Preventing Voltage Regulator Latch-up on the A&D Board

{Revision 1.0, by Bob Lineberry, 3 November 2005}

Figure 7. Split power supply (± 12V/1A)

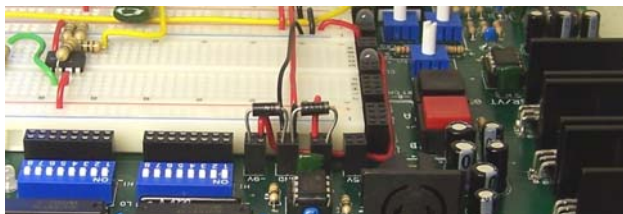
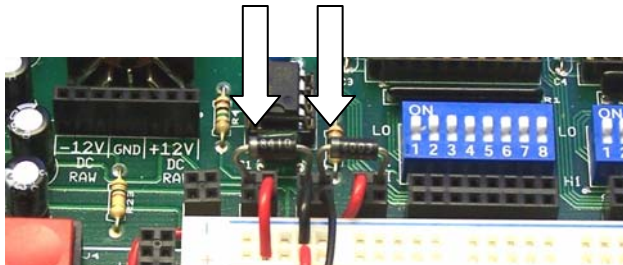
Several students have experienced the loss of minus 9 volts, when performing lab exercises on the RSR/VT A&D Board. After testing several possible solutions, ECE Technical Support recommends adding transient suppression diodes.

We recommend that students add 2 diodes to the power supply socket headers, as shown in the following pictures. Please note the stripe on the diode, which designates the cathode. The stripes on both diodes should face away from the DIP Switch.

Students may obtain free 1N4003 diodes in 368 Durham, during normal CEL open hours.
